Smart Network ADC Processor (SNAP) Design Manual

Status: Draft
2014-11-18

5.3	Comments from Schematic Reviewers	23
5.3.1	Jason Ray's and Randy McCollough's Comments	23
5.3.2	Dan Werthimer Comments	23
5.3.3	Matt Dexter Comments.....	24

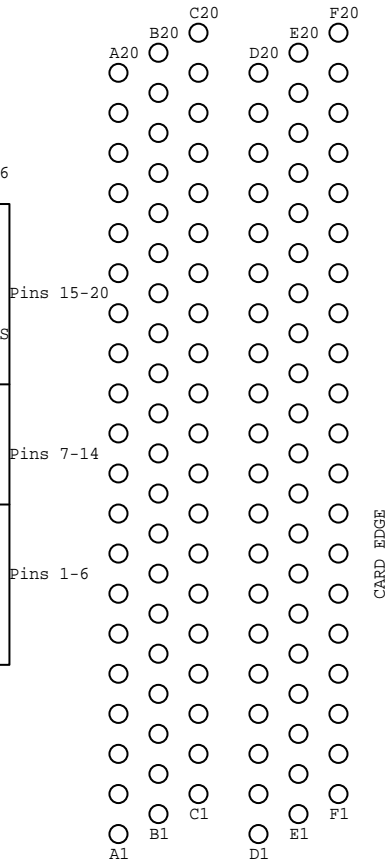
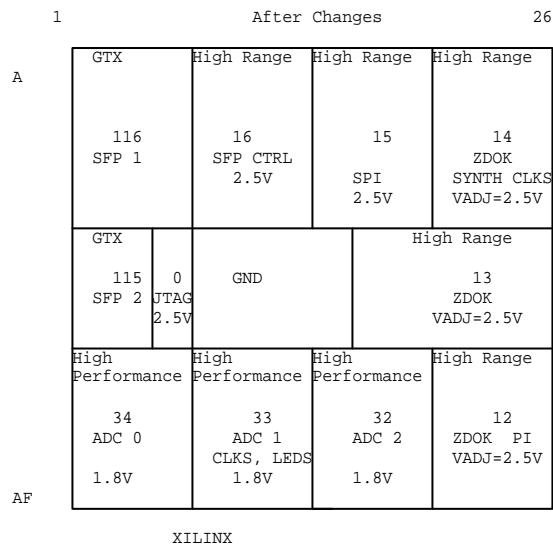
One thing I did notice -- on the SNAP board the PROM SPI connections are all to bank 15, whilst in the KC705 they are to the bank 14, matching the specs in the config guide --
http://www.xilinx.com/support/documentation/user_guides/ug470_7Series_Config.pdf

-- I could well be missing something, but is this correct?

Change 33 to 1.8V and move ADC 1 to it.
Use only MRCC clocks for the ADCs
Move ZDOK to 16 to 14, SPI 14 to 15, and sfp ctrl to 15 to 16
Redistribute ZDOK pins.
Change ZDOK to 2.5V VCC0 so can use LVDS-25 See UG471.
Change 100MHZ OSC to 200 MHZ. and eliminate termination resistor.
Replace 5V linear regulator with a DC-DC converter
Reduce number of TI Power Supply Controllers from 3 to 2
Remove C196 which wasn't connected to anything.
Add J9 as a test connector
Go to a single dual SFP+ Cage instead of two single cages.
Add a vertical USP J10 in parallel with horizontal USB J4
Change U43 from a 128 MByte to a 256 MByte Flash Memory.

The following photos show the solder bridge.

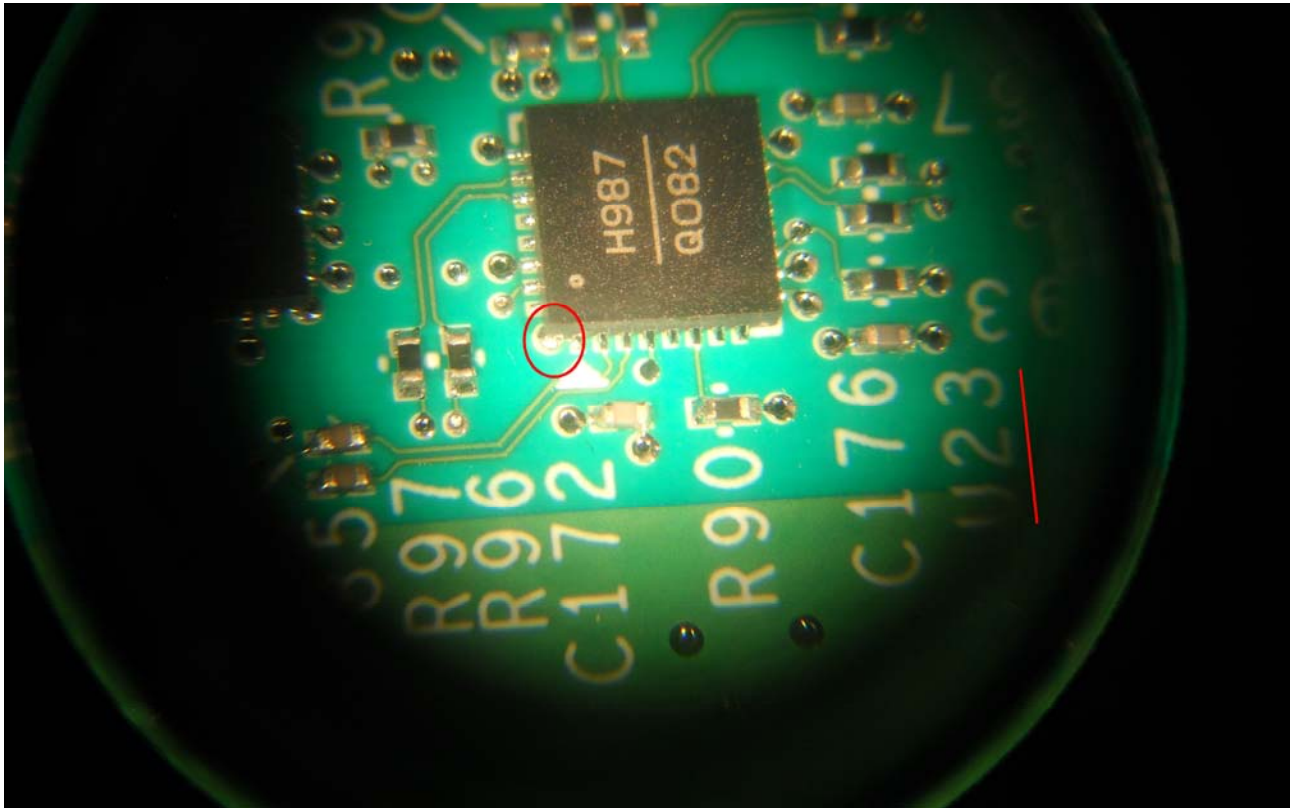
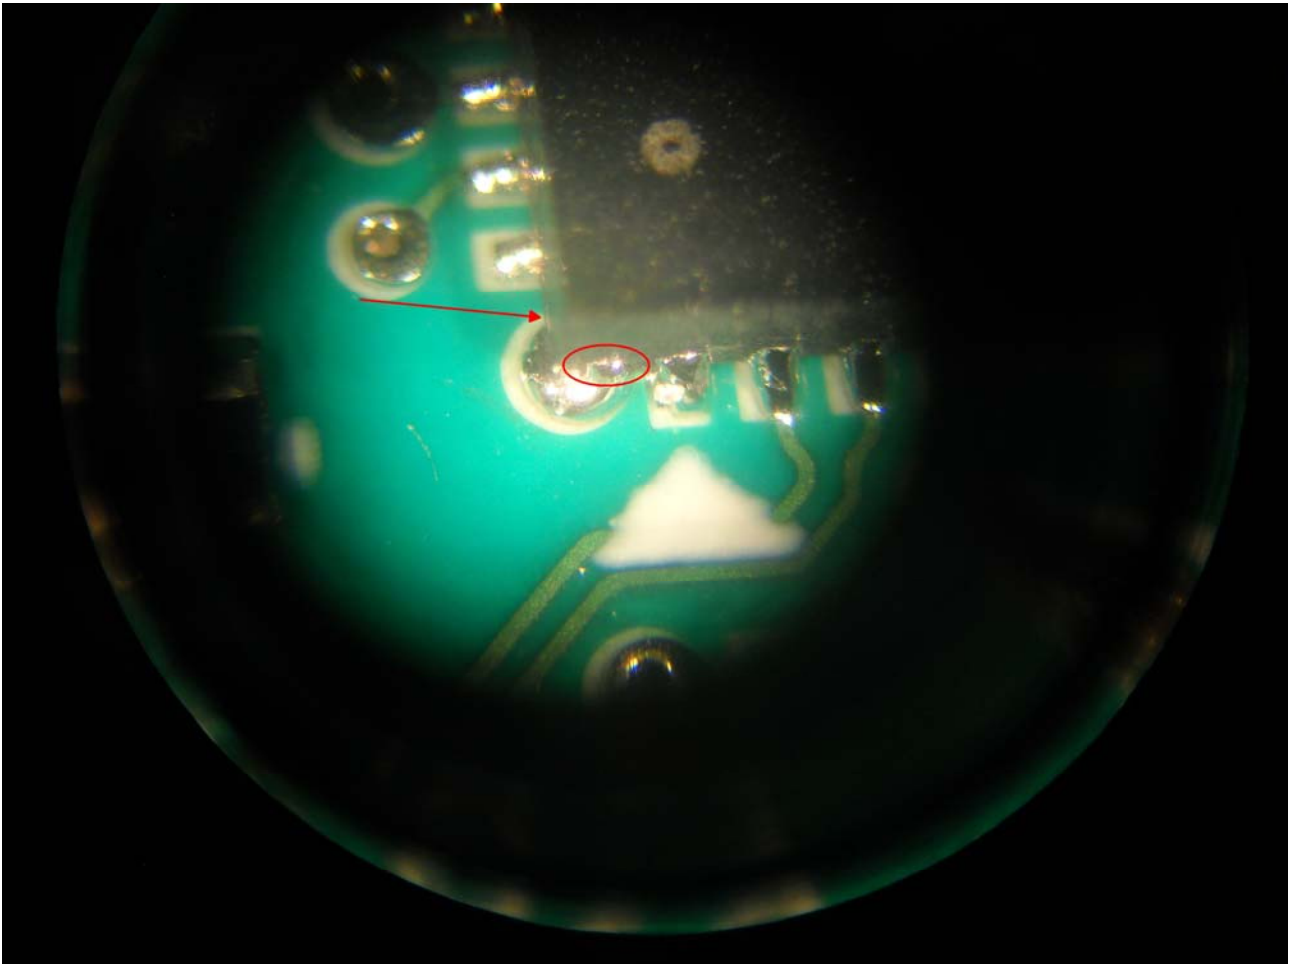
On one of the shorted boards, we had earlier removed a solder short adjacent to pin 1 of U23. This package has exposed metal at each corner, in the same plane as where the pins exit the package. This exposed metal is flush with the package surface and is pointed out with the arrow in U23-B. The short occurred between the exposed metal adjacent to pin 1 and the via which is directly beneath it. As far as I know, this only occurred on one assembly. I will see about moving that via in the respin to reduce the risk of this happening. The solder on this via seemed a bit excessive, but I could not determine if it crept in from the solder applied to the thermal pad or another part of the process.

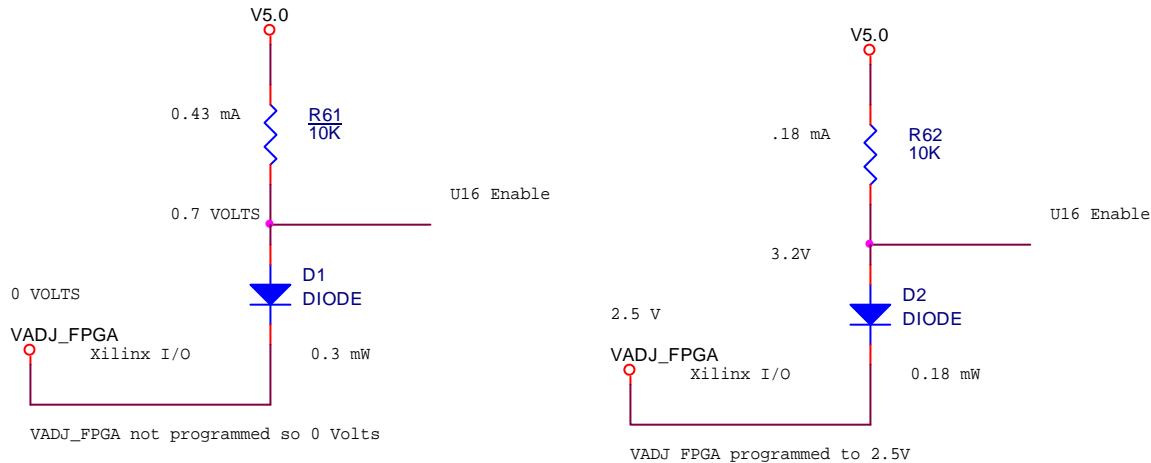
The 10K resistor limits the power in the diode to 0.3 mW, which should be safe.

Once VADJ_FPGA is programmed to 2.5V, then there should be 3.2 V to U16's Enable. Diode dissipation would then be 0.18V.

Since we are exceeding the maximum input voltage, a proper change for the next version would be to use VADJ_FPGA as the pullup voltage instead of V5.0.

10.9 Make JTAG Connectors Standard Pinout

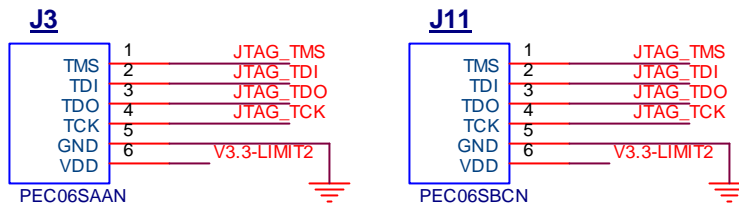
J3 and J11 are currently wired as shown below. This corresponds to the standard used on NRAO boards.
